## **AMENDMENTS TO THE DRAWINGS**

### **REMARKS**

TSMC2003-979OA Response.doc

FIG. 1 (PRIOR ART)

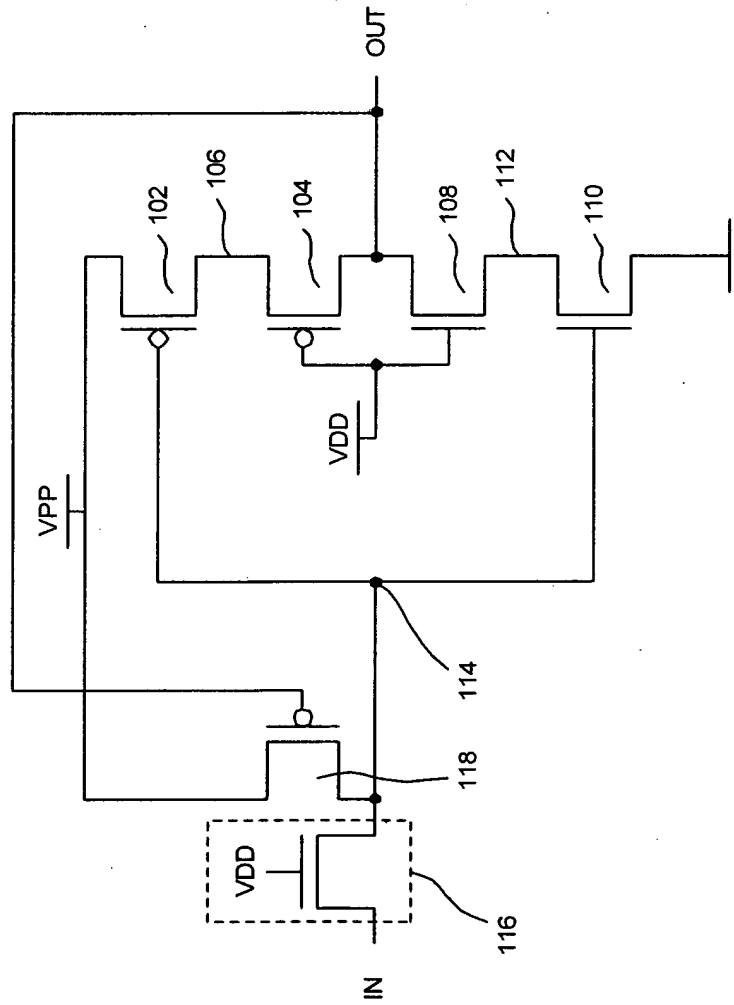
FIG. 1 is objected to for omitting a phrase "prior art." Such phrase has been added to FIG. 1 as shown in the replacement drawing sheet attached hereto. Thus, the objection is hereby overcome.

The attached sheet of drawings includes changes to FIG. 1. This sheet, which includes FIG. 1, replaces the original sheet including FIG. 1. In FIG. 1, previously omitted phrase "(PRIOR ART)" has been added.
